# Comments on P802.1AEef D0.3 (8<sup>th</sup> February 2026)

Alexander Zeh, Florian Mendel  
Infineon Technologies AG  
Munich, Germany

## Abstract

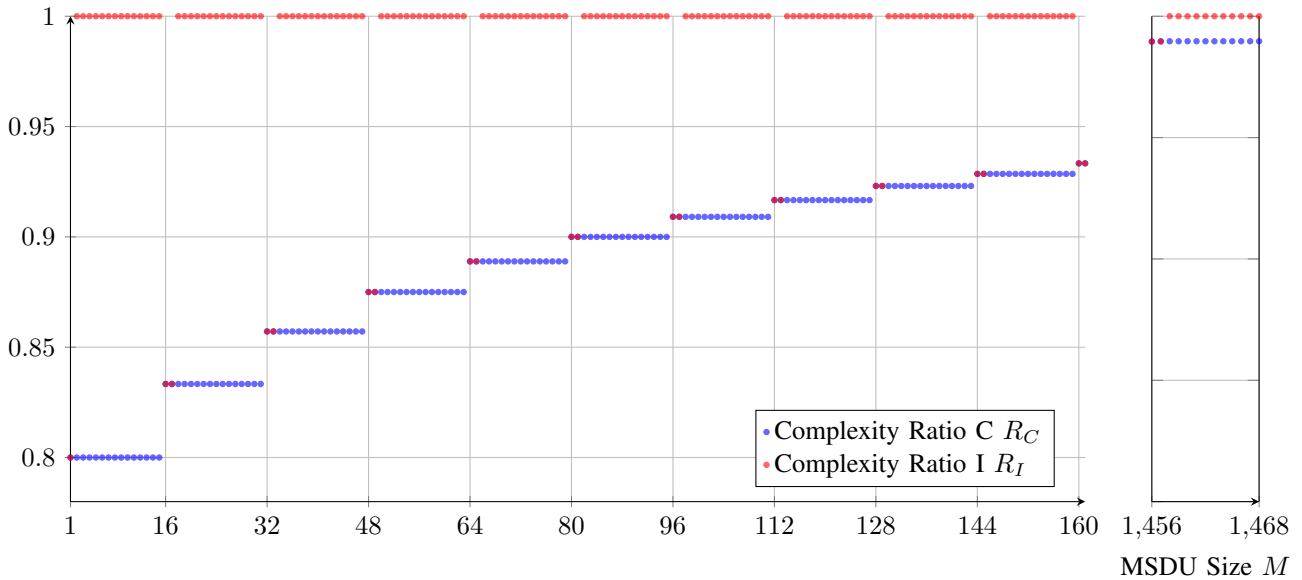
For short frames with  $M < 16$ , we obtain  $R_C(< 16) = 4/5$ , while  $R_C(1456) = 95/96$ , meaning a saving of  $1/96 = 1.04\%$ . We illustrate  $R_C$  as in (5) in Fig. 2 (in blue).

Note that for  $M = 16$ , we obtain  $R_I(16) = 5/6$ . We plot both complexity ratios  $R_C(M)$  as in (5) and  $R_I(M)$  as in (7) in Fig. 2.

We revisited how Ethernet header fields are mapped to Ascon inputs in MACsec and proposed a minimal change that removes an avoidable 128-bit absorption of associated data. Specifically, by moving the two octets TCI || AN || SL from A into the nonce, the authentication data shrinks from an exact 16 octets to 14 octets, so Ascon's padding no longer forces a second block  $A_2$ . This simple repartitioning preserves the on-wire MACsec frame format and nonce uniqueness requirements while reducing the number of Ascon calls needed to process a frame.

Our analysis quantifies the savings. In confidentiality protection mode the complexity reduction yielding up to 20% fewer cryptographic operations for very short MSDUs. In integrity protection, we obtain up to 16.7% fewer operations.

We therefore recommend adopting the proposed A/nonce repartitioning for Ascon in IEEE P802.1AEef. Alternatively, the size of the authentication data could be reduced by other measures, such as removing the EtherType field.
